**Placer County Office of Education**

HVAC Package Unit Replacement

**ADDENDUM NO. 1**

Tuesday, May 26, 2025

Sheet  
**A0.01**  
Sheet of

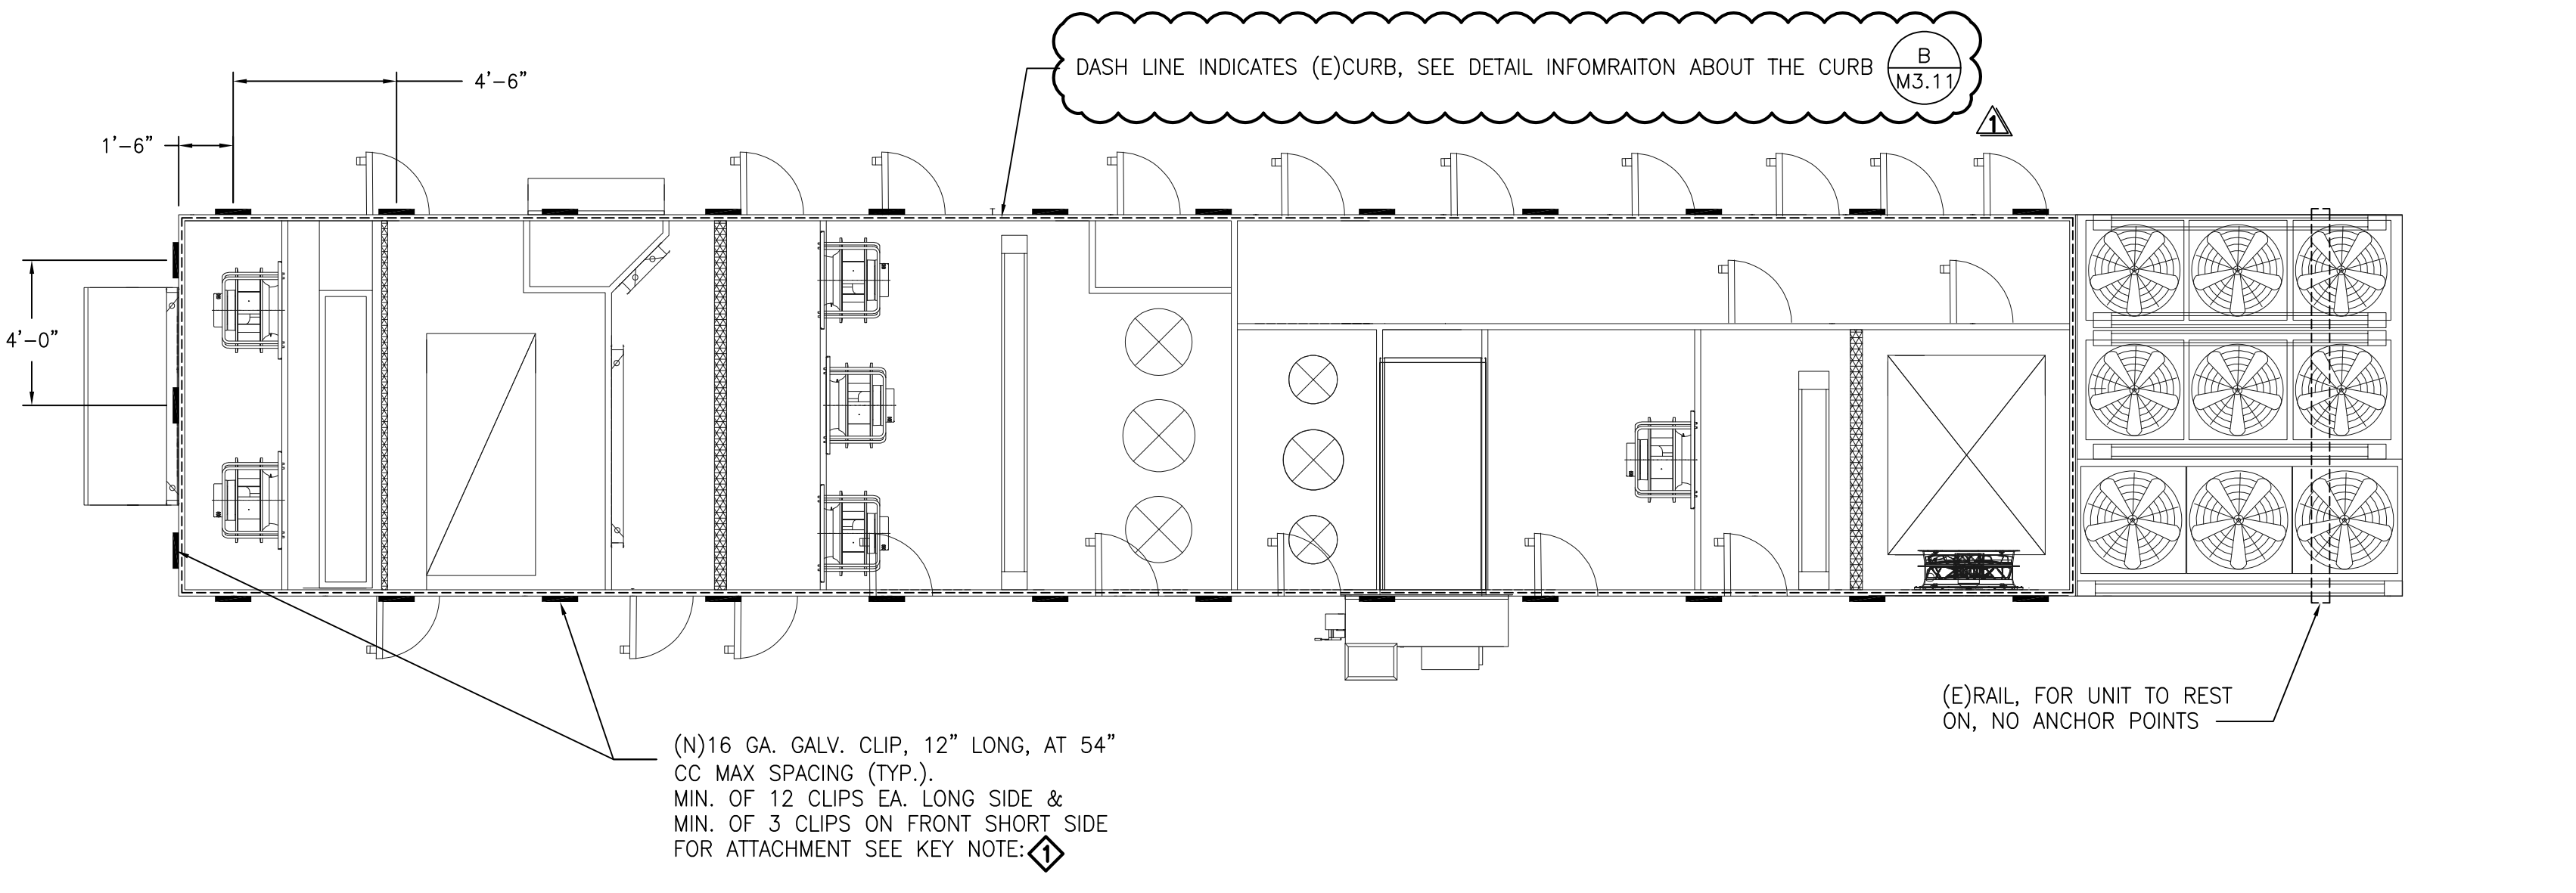
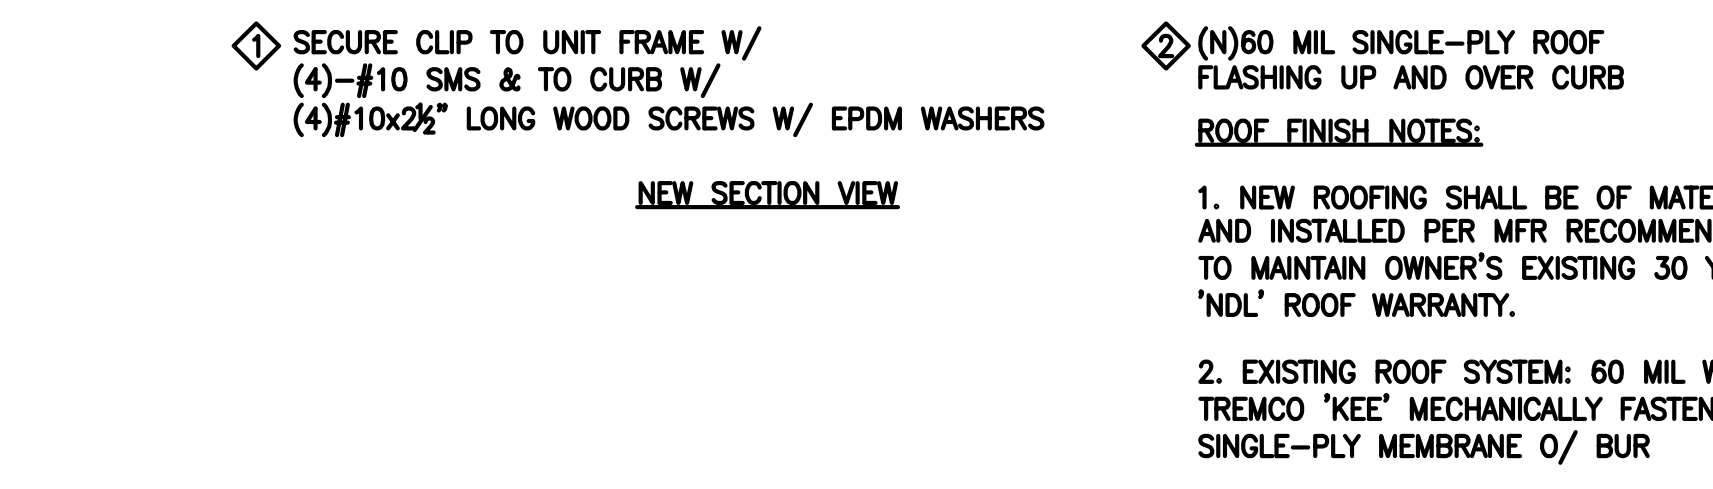
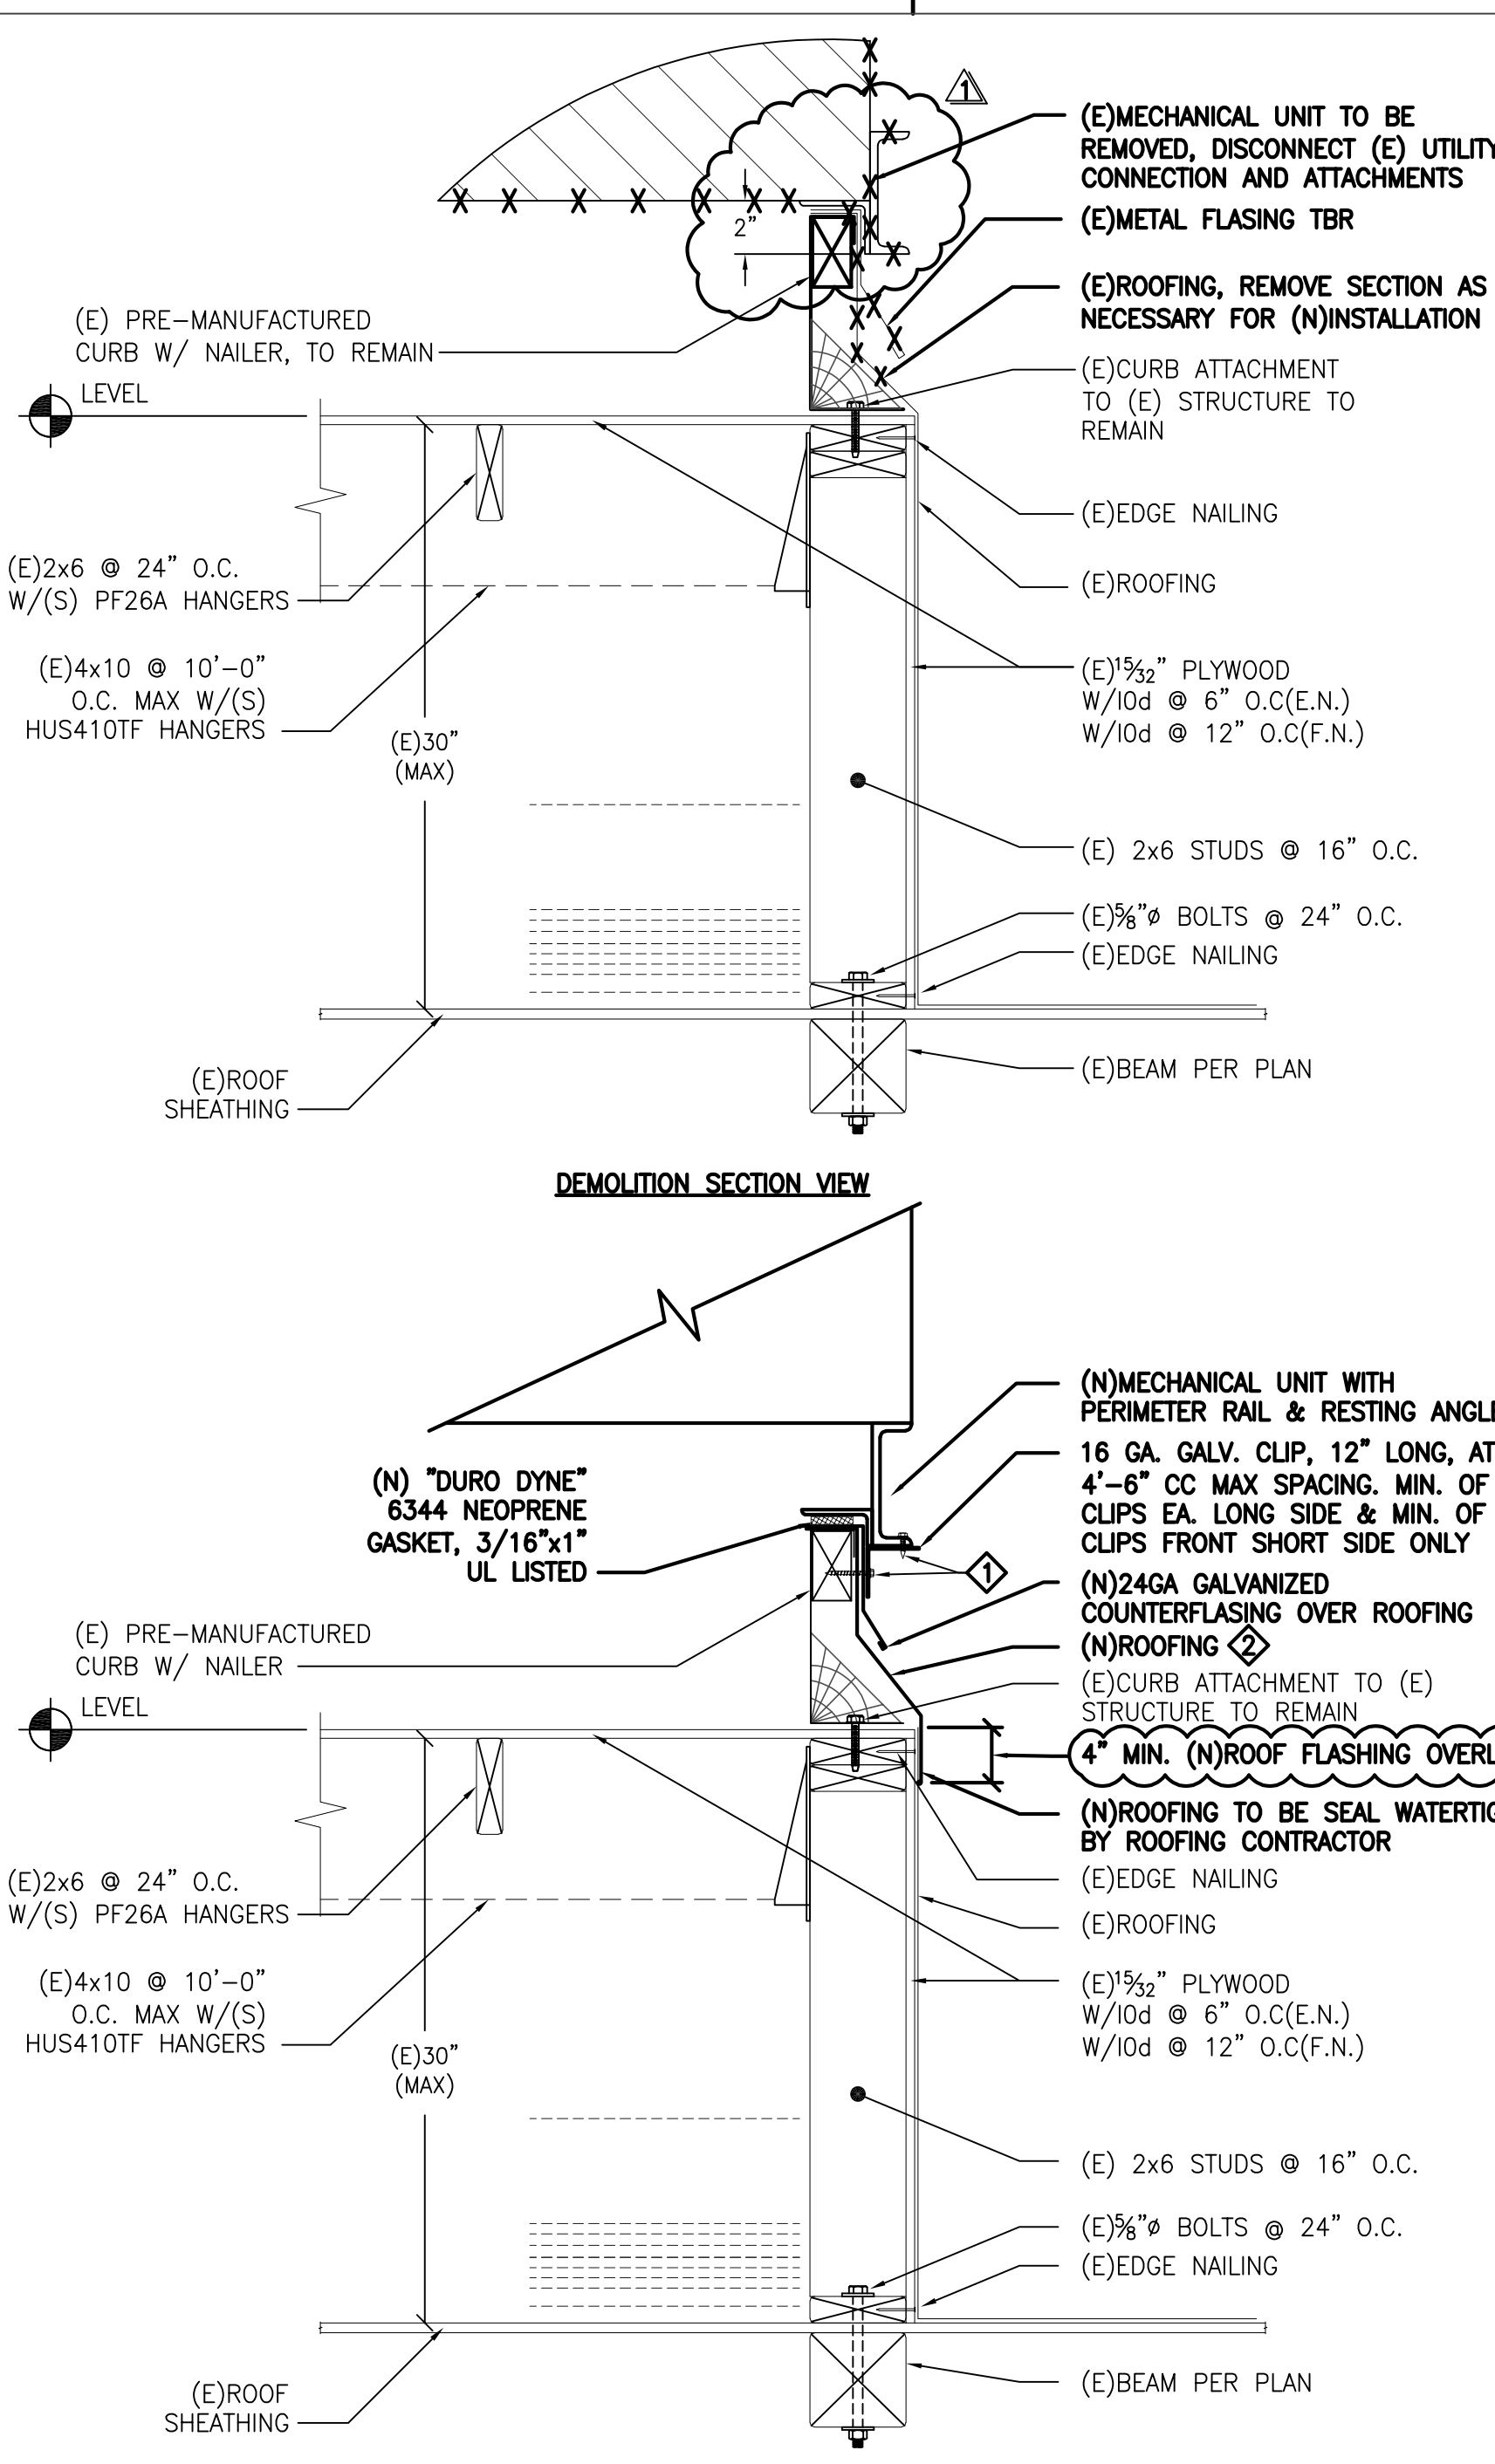
1. Sheet A0.01
  - a. **REVISE:** 'Scope of Work' information to include general electrical related work. See attached.
2. Sheet M0.01
  - a. **REVISE:** Detail A on sheet M0.01 updated to graphically show the existing condition clearly.

- REMOVE EXISTING ROOFTOP AIR-HANDLER PACKAGE UNIT (CUSTOM DUAL FAN, DUAL DUCT CHANGEOVER SYSTEM) AND REPLACE IN-KIND.
  - A NEW REPLACEMENT UNIT SHALL WEIGH LESS THAN OR EQUAL TO THE UNIT TO BE REMOVED AND SHALL BE SIZED TO FIT OVER THE EXISTING CURB.
- ELECTRICAL POWER, FIRE ALARM DUCT DETECTORS AND CONNECTIONS.

**UNIT MOUNTING DETAIL**  
NO SCALE

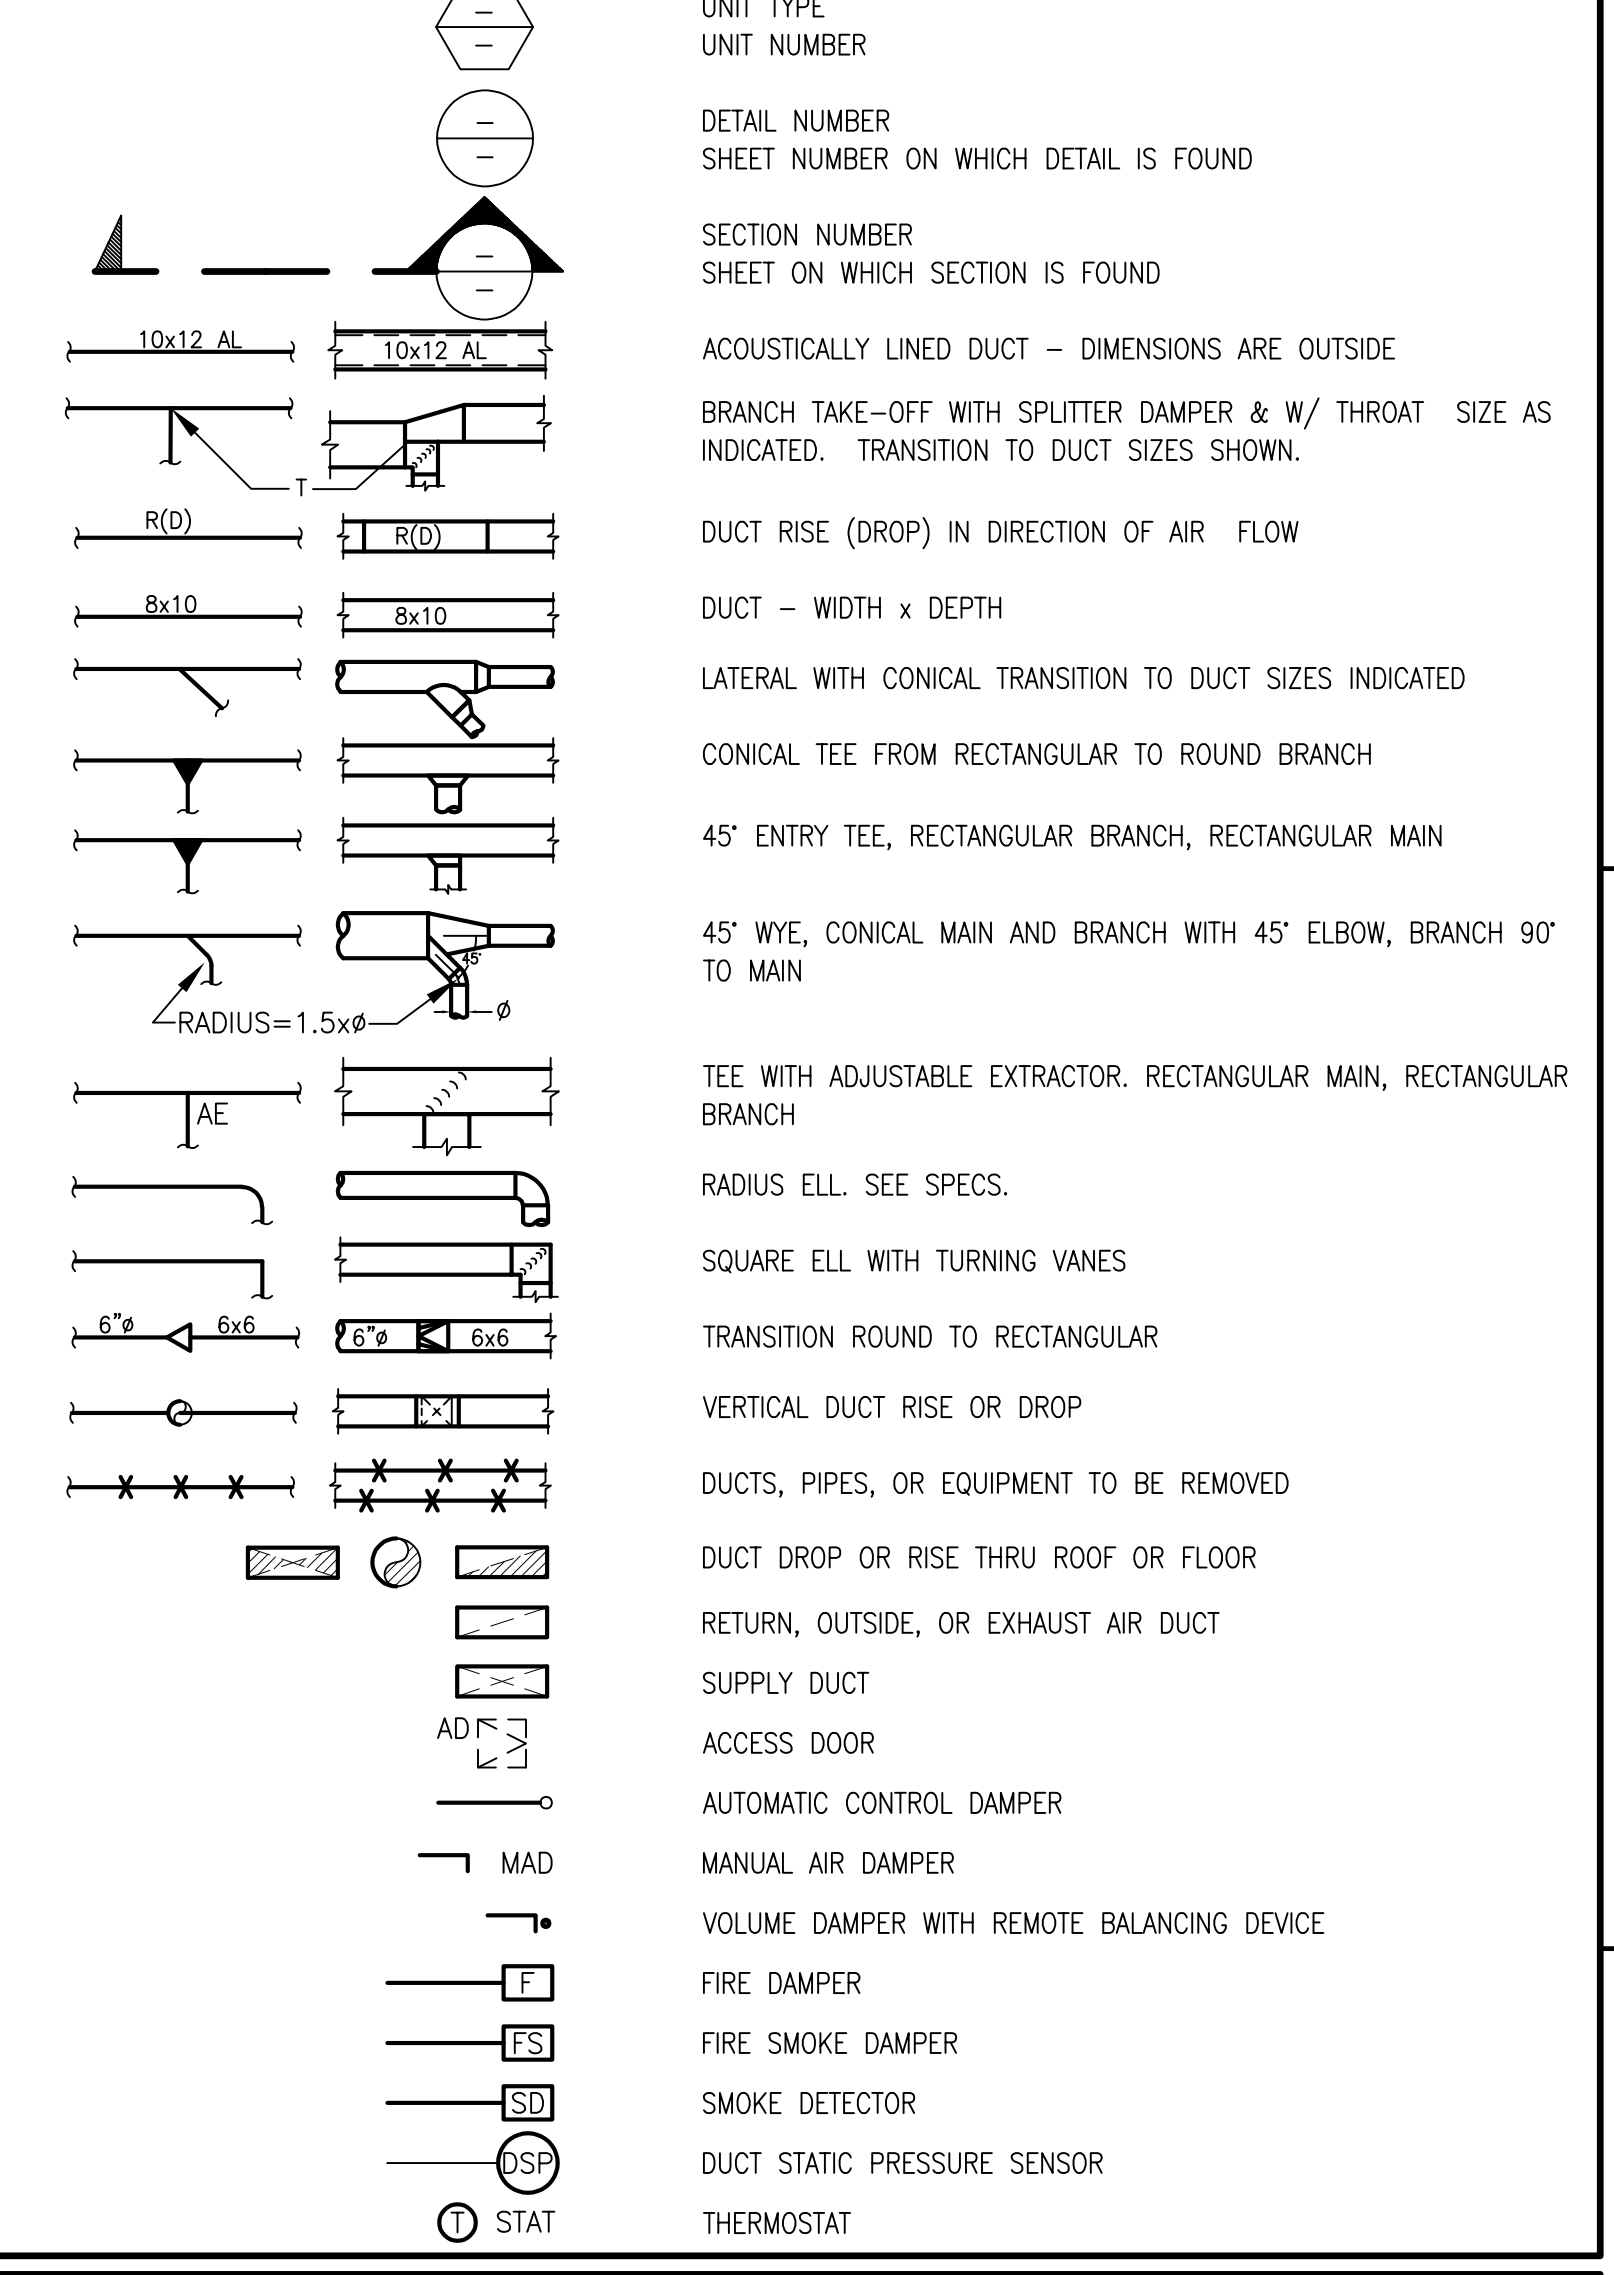
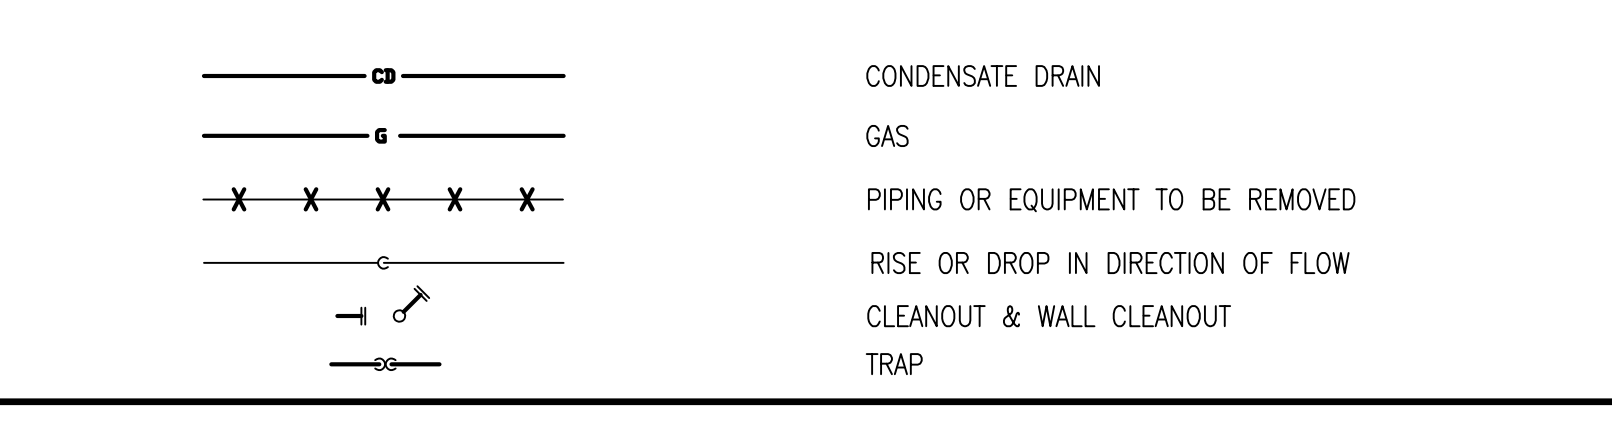
- b. **REVISE:** The plan view; scaled larger for clarity so that the existing curb outline is visible. The reference is added for the existing curb on sheet M3.11

- c. **REVISE:** The new HVAC unit schedule to identify the CSFM listed smoke detector in the unit and quantity of the duct smoke detector clarified.
